Info Only: Comments from Service
Engineering and Stormwater Engineering
are in blue text.

EPC STORMWATER REVIEW COMMENTS
IN ORANGE BOXES WITH BLACK TEXT

Final Drainage Report
for
Rolling Hills Ranch North Filing 2
at
Meridian Ranch

July 2024

FIGURE 6

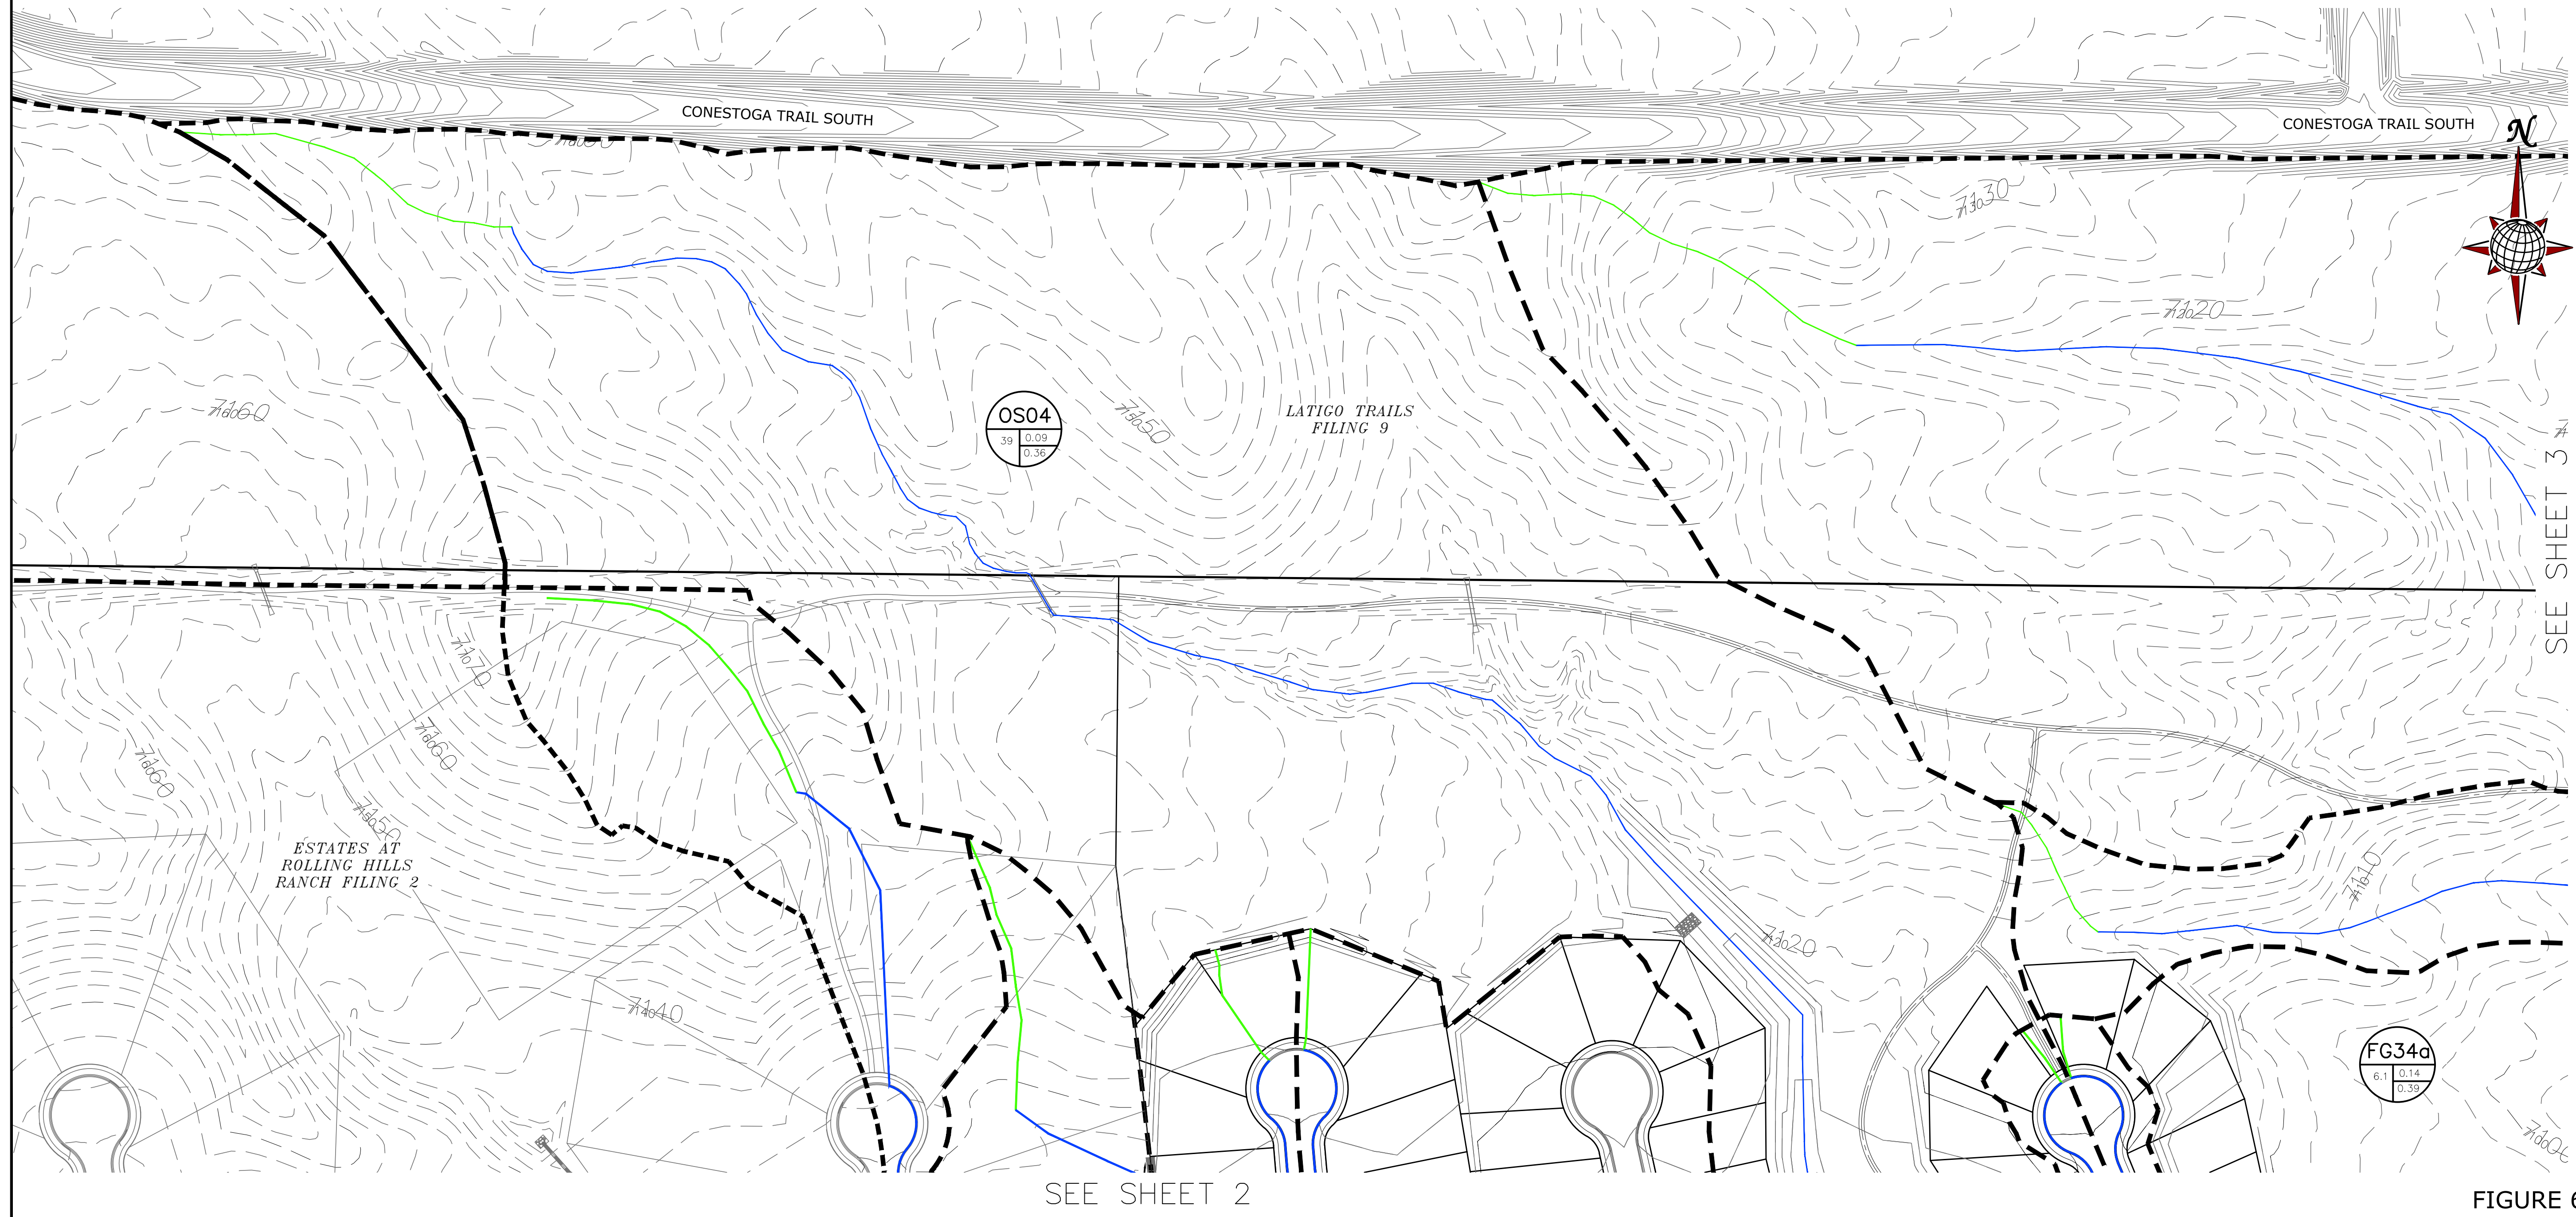
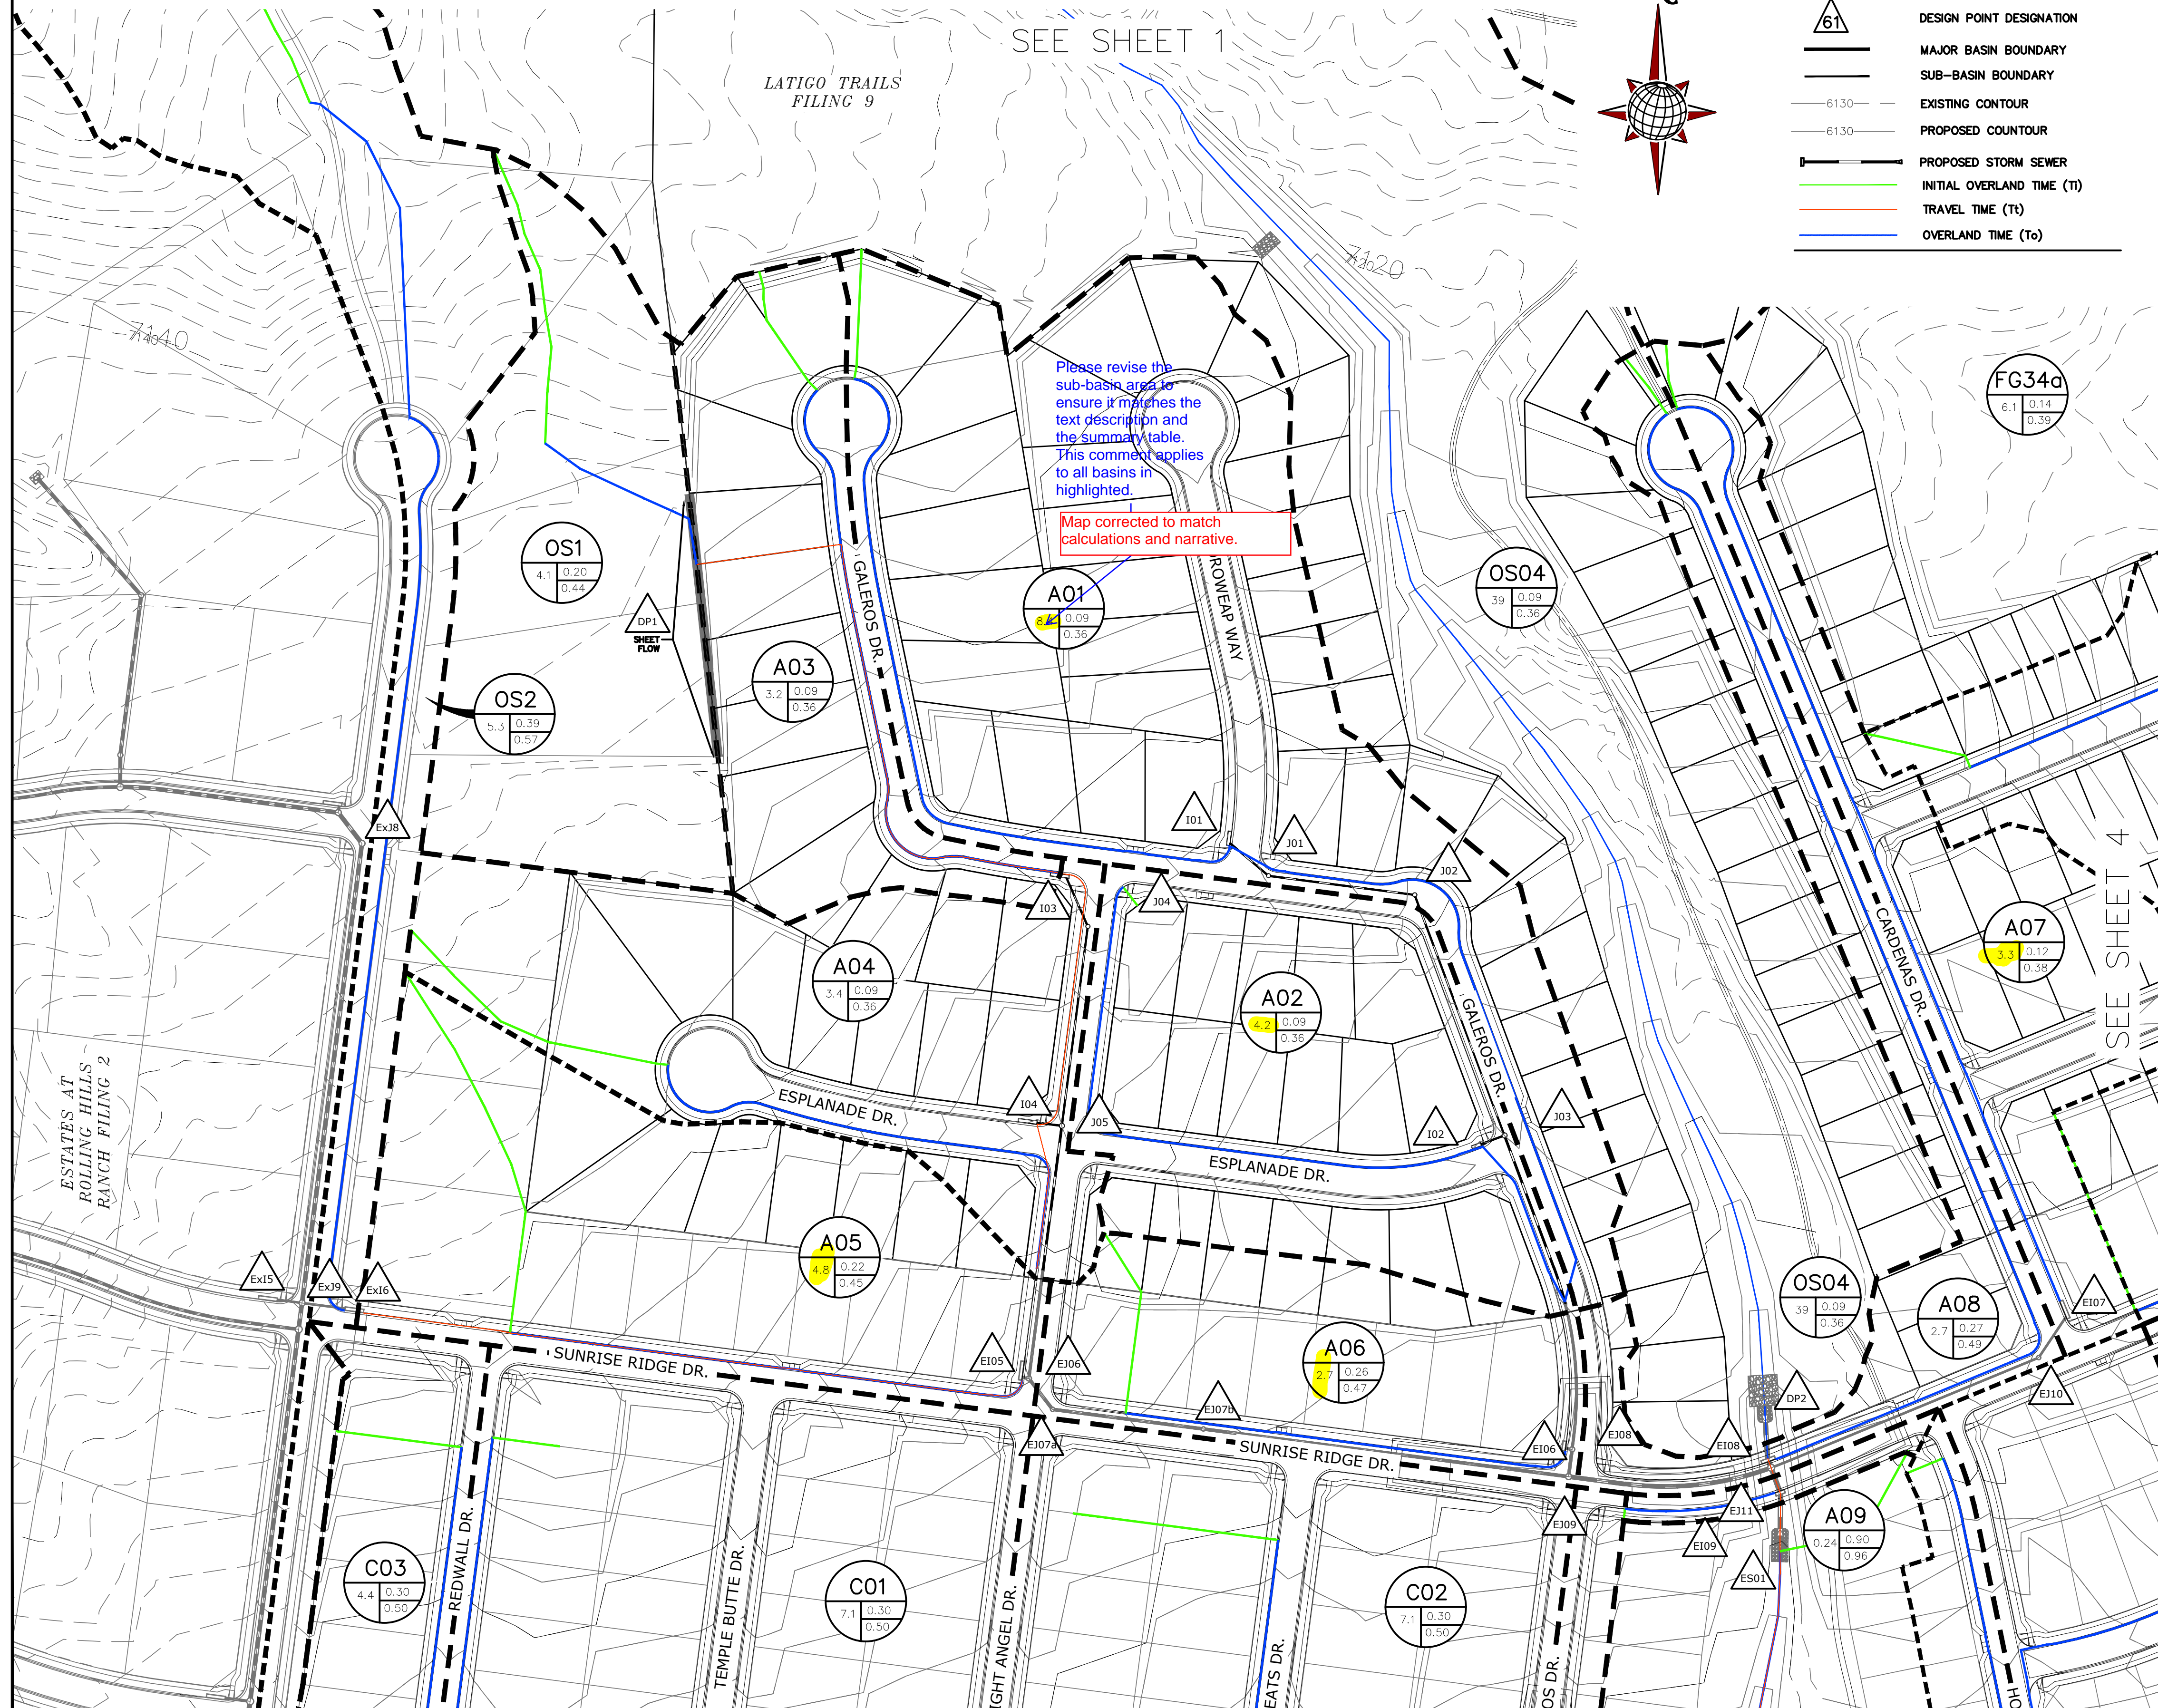
The chart shows data from the storm drain system and does not include surface runoff.
 No change
